# HURRICANE CITY UTAH

### Hurricane Planning Commission Meeting Agenda

March 10, 2022

FINAL PLAT  
FOR  
NORTH SLOPE AT COPPER ROCK - PHASE 2 PARTIAL AMENDMENT A  
LOCATED IN  
SECTIONS 21, TOWNSHIP 42 SOUTH, RANGE 13 WEST S1/4&M,  
CITY OF HURRICANE, WASHINGTON COUNTY, UTAH

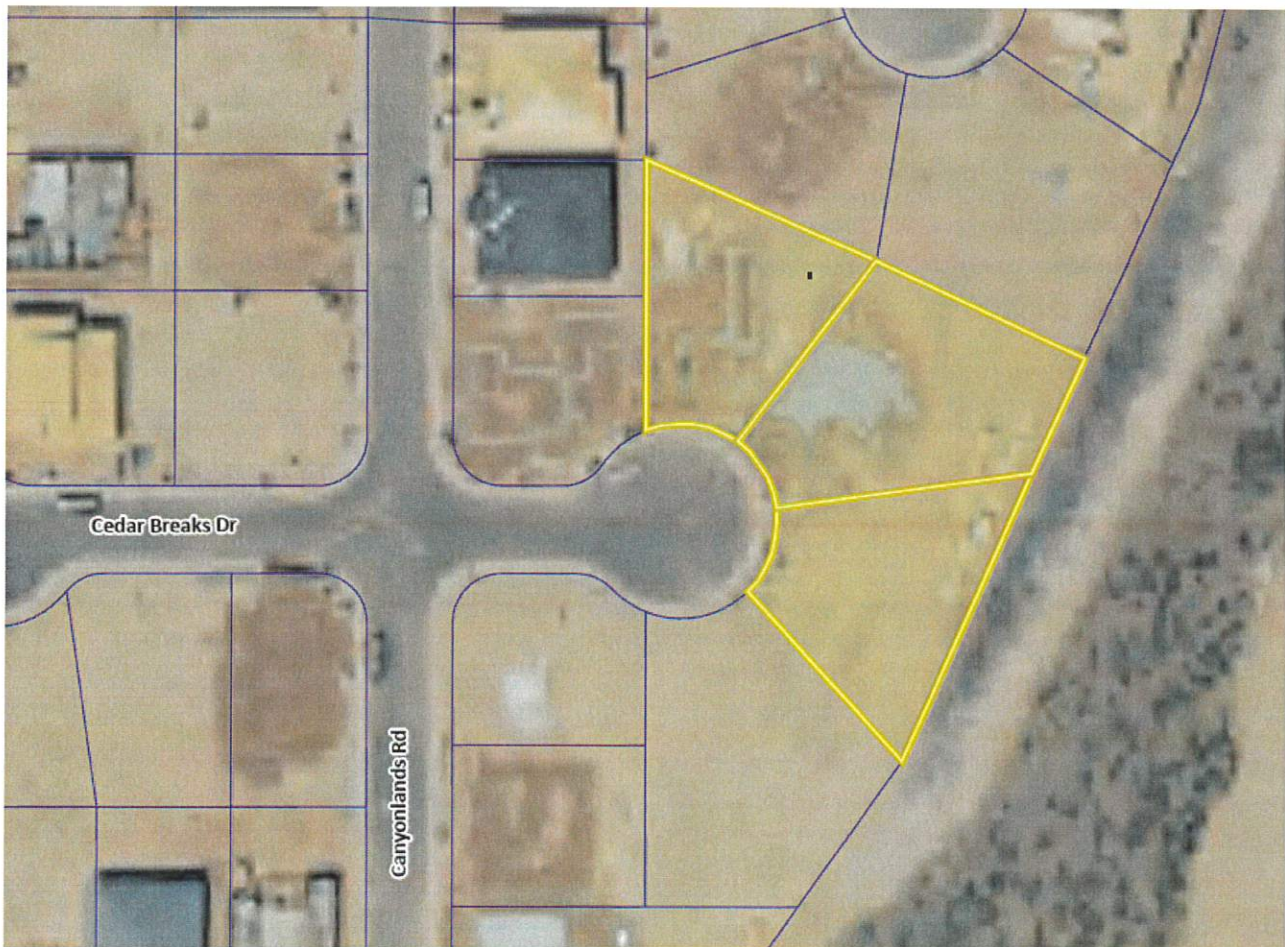
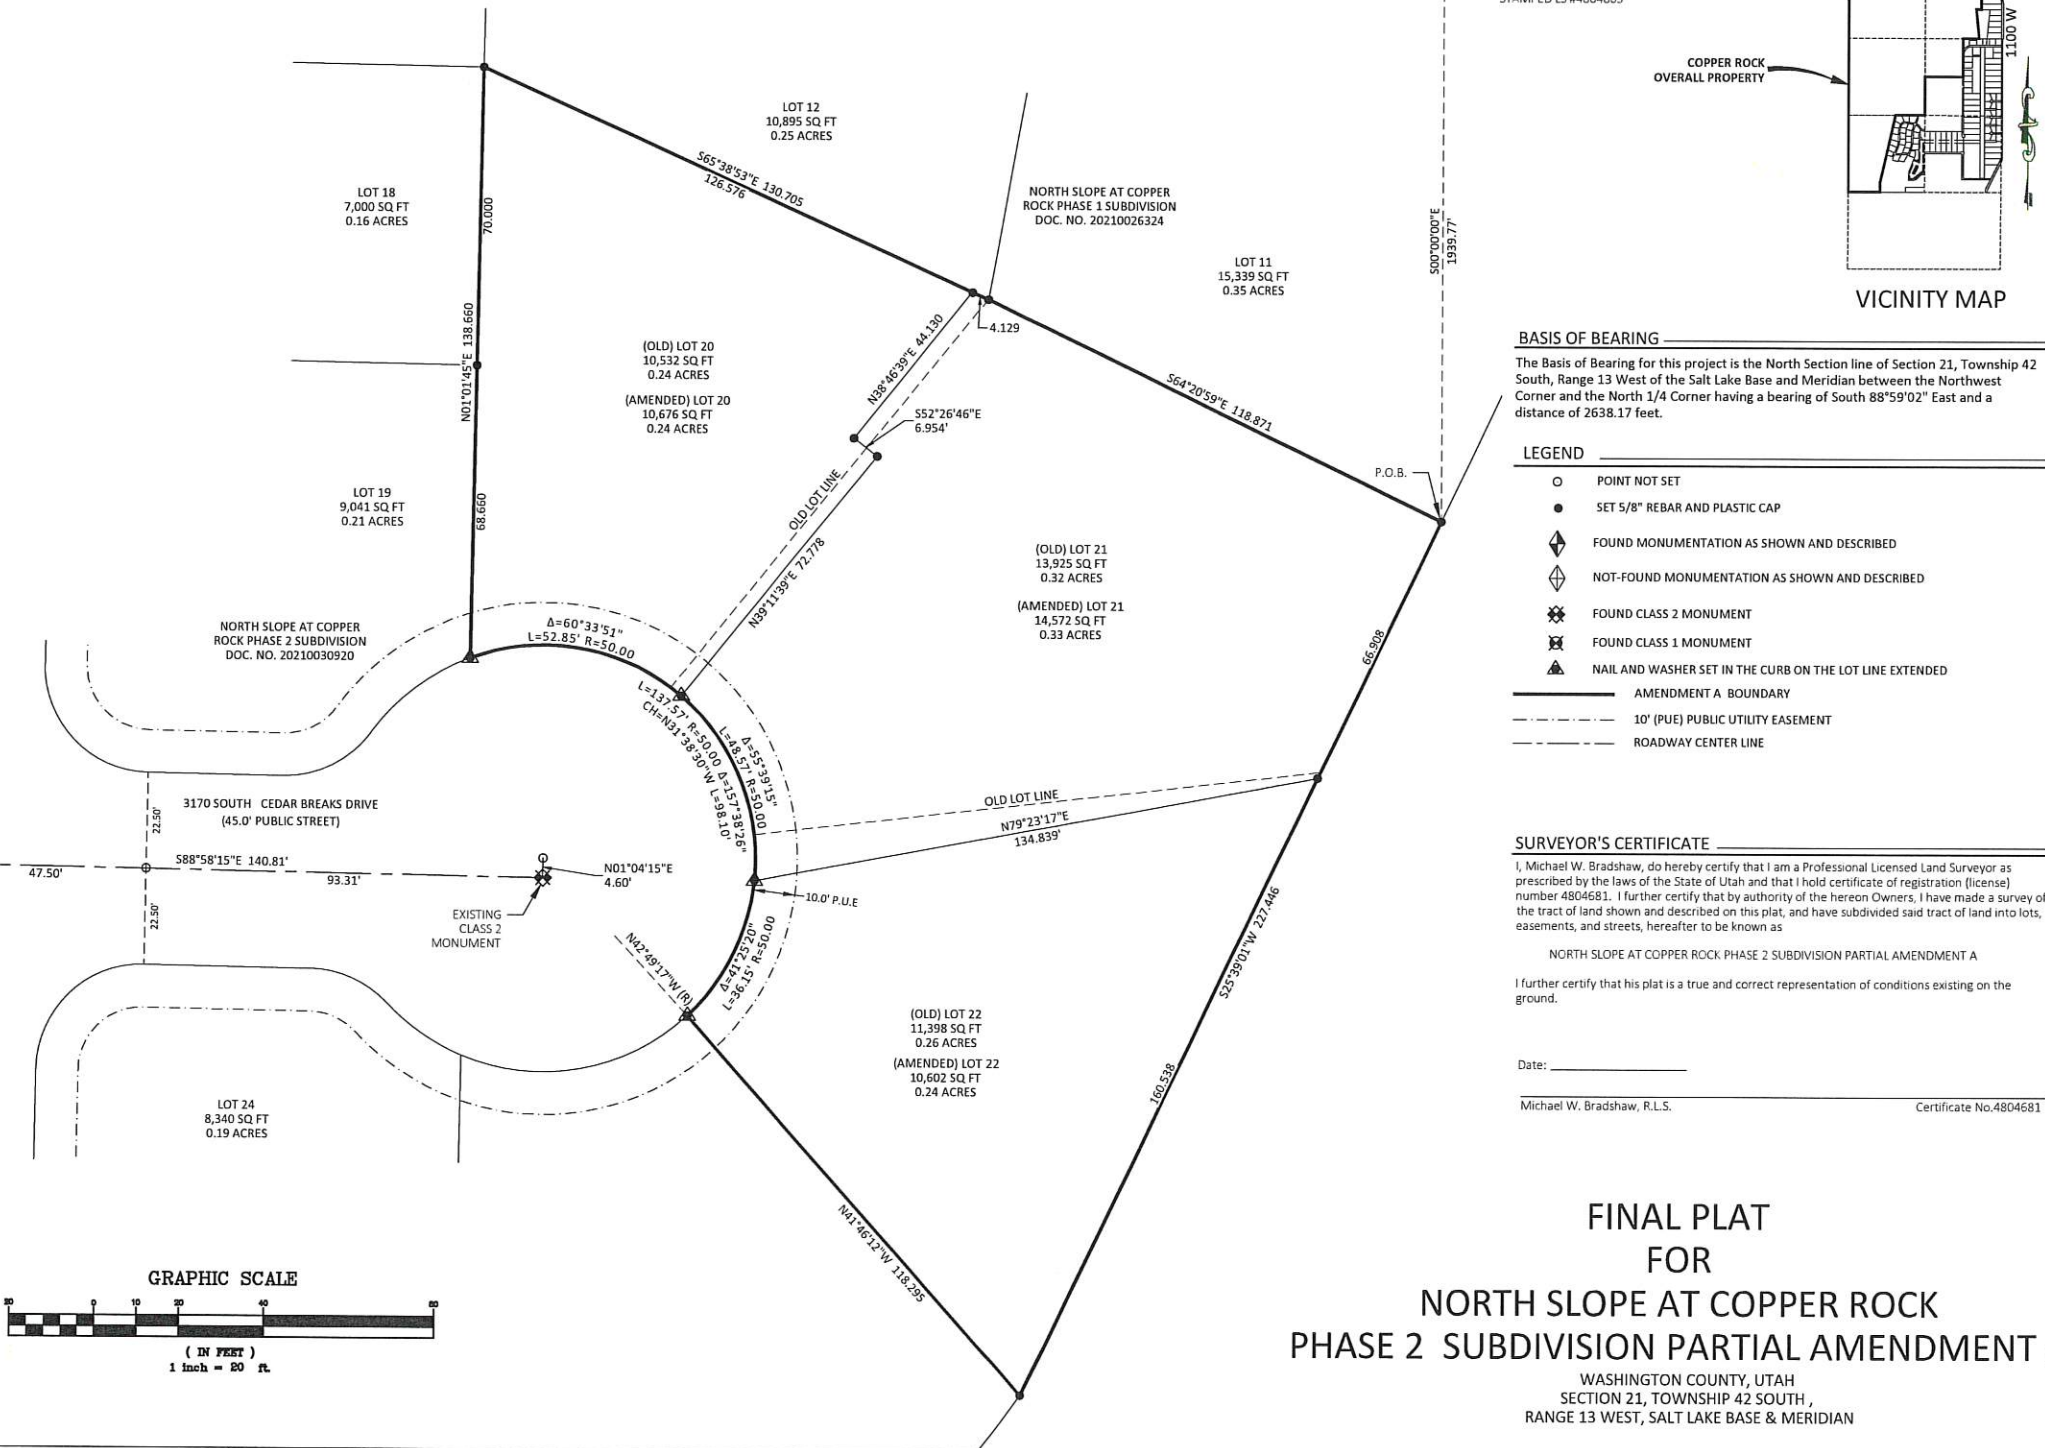
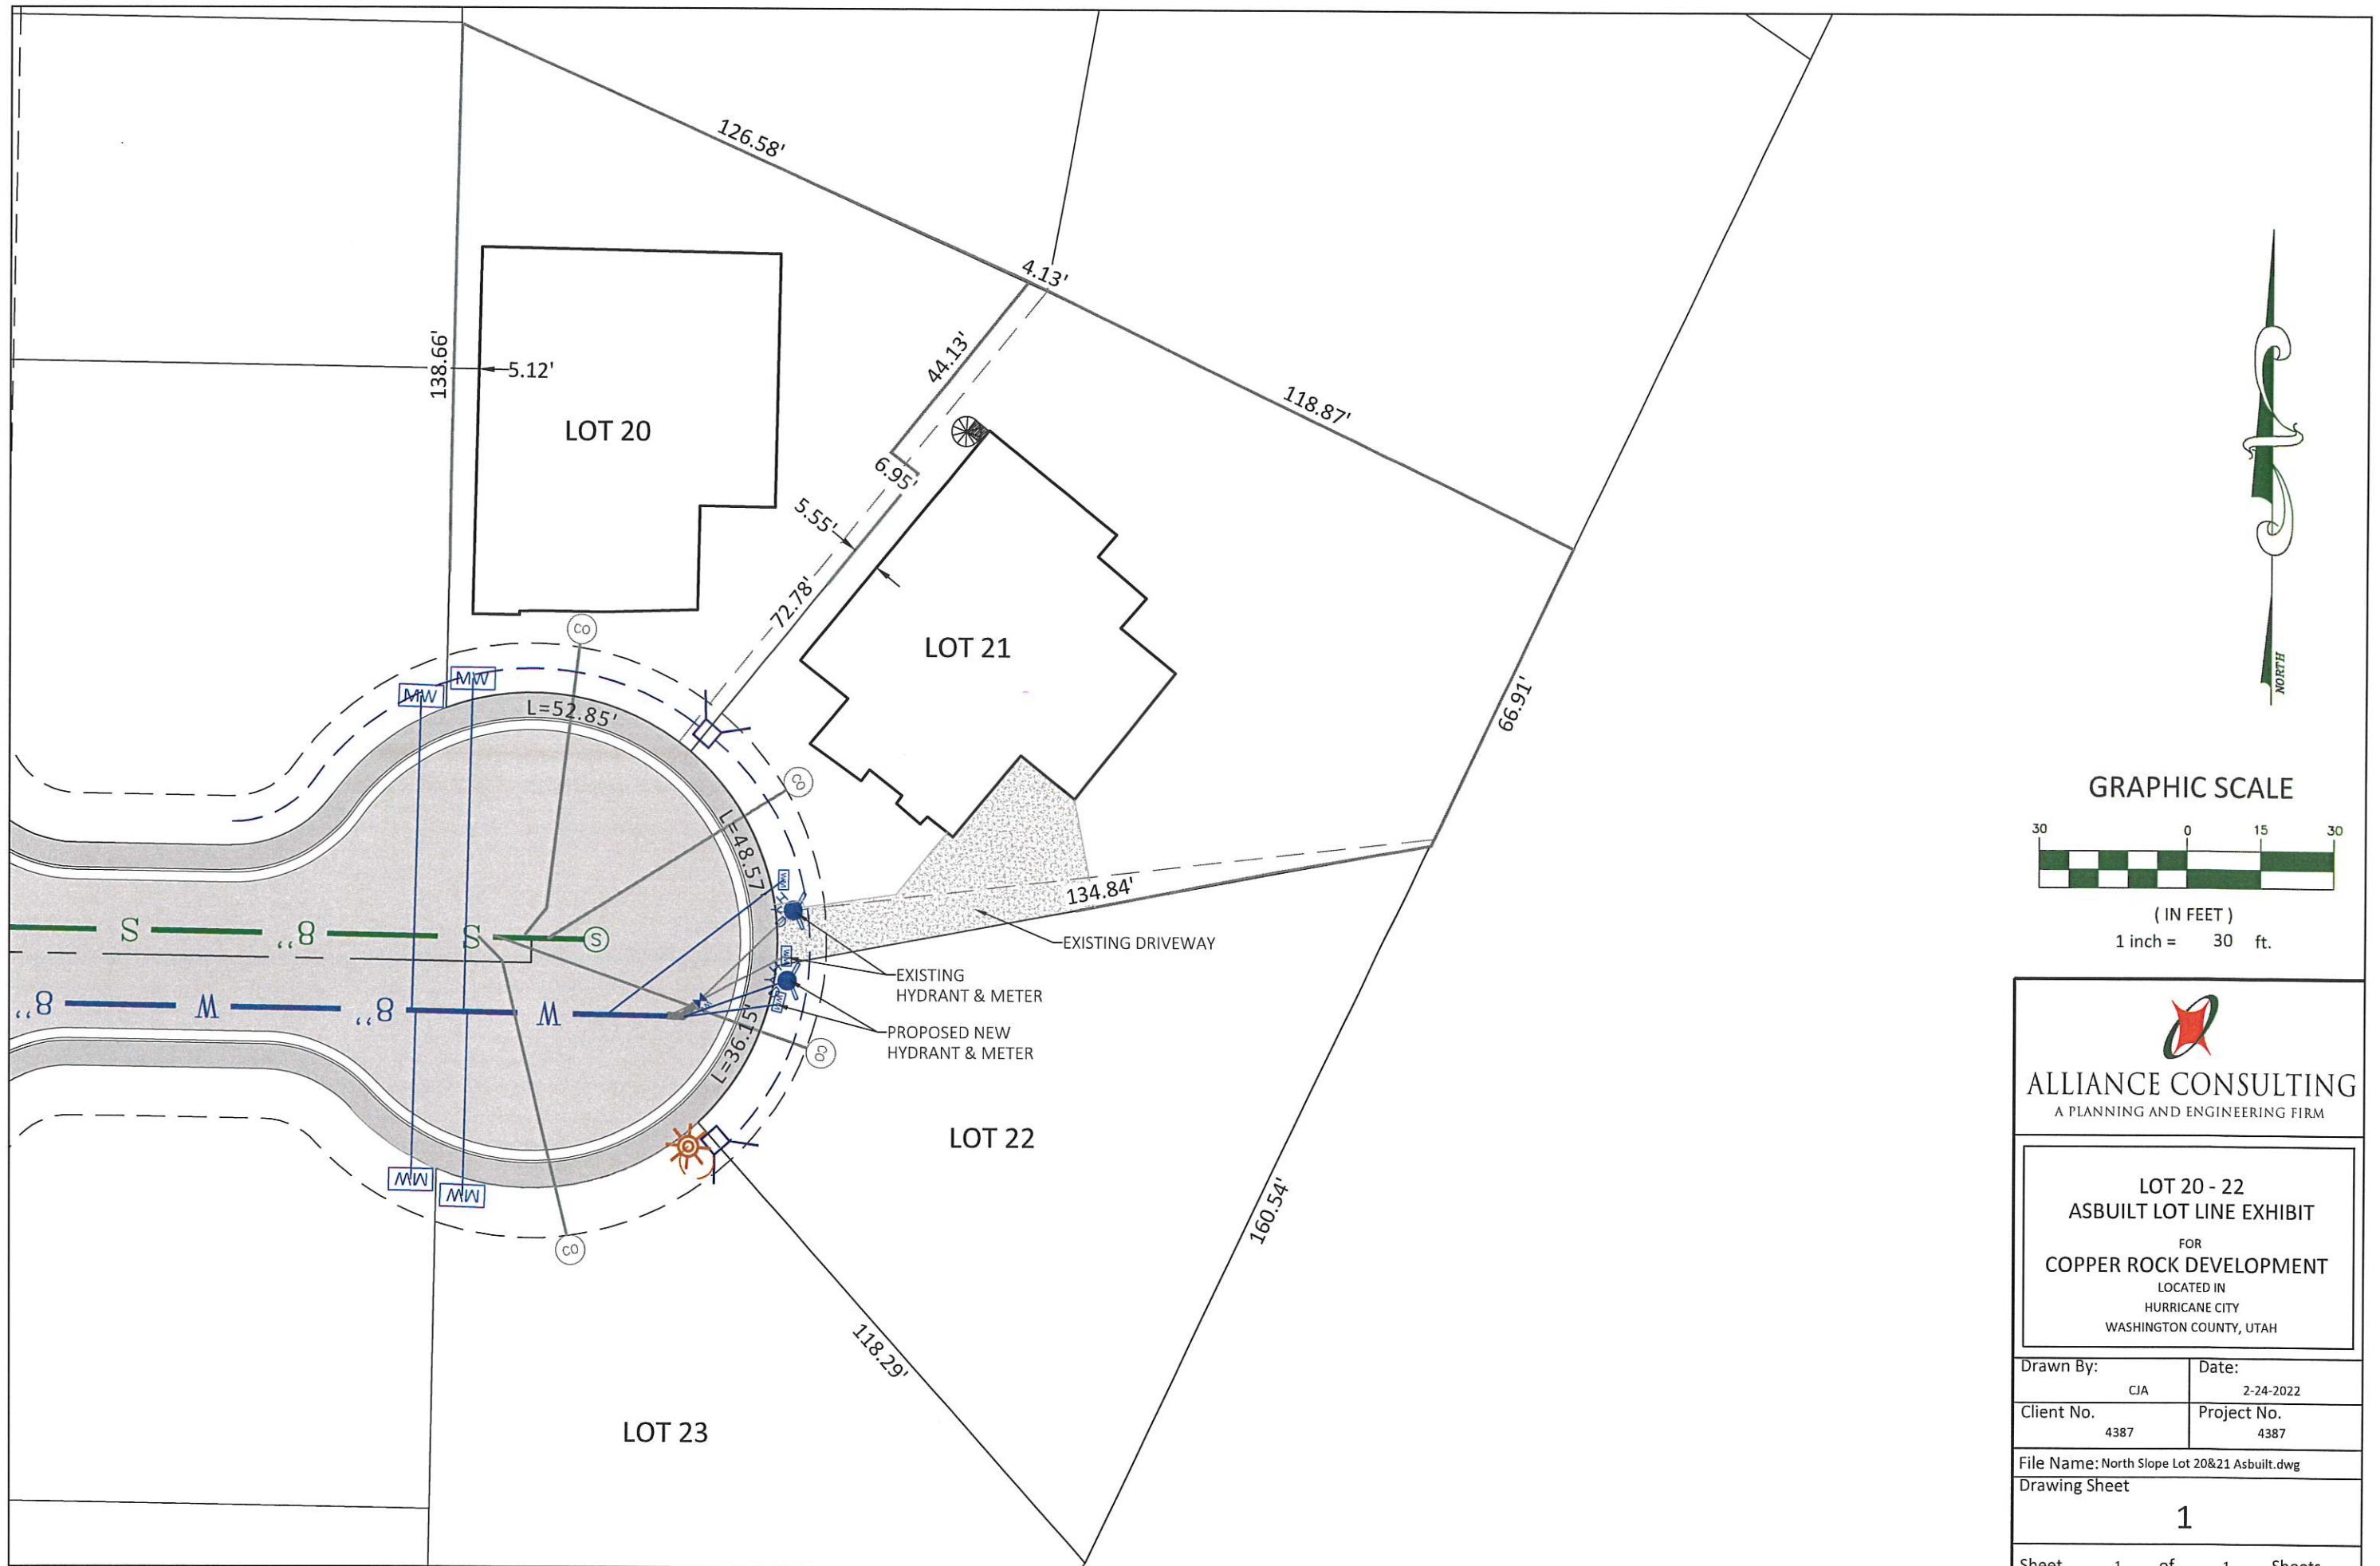
**Discussion:** The applicant has applied to amend the final plat for North Slope at Copper Rock Phase 2 to change the lot lines for lots 20, 21, and 22.

4. *Lot area and width. A planned development shall not be subject to the lot width and lot area requirements of the underlying zone in which the development is located. The area and widths of lots shall be shown on an approved site plan.*
5. One of the staff's main concerns is that the home meets the proper setback lines. There has been construction that has started on these lots for new homes. However, the applicant has not provided any information to ensure that these lots will still maintain the proper side-setbacks, which is 5' and a total combined of 15' of each side.
6. The properties meet the requirements of the R1-10 PDO zoning

**Recommendation:** Staff recommends that the Planning Commission review this application based on Hurricane City and State Code standards. Staff would recommend continuing the items unless the applicant can provide additional information about home location on the lots with this application.
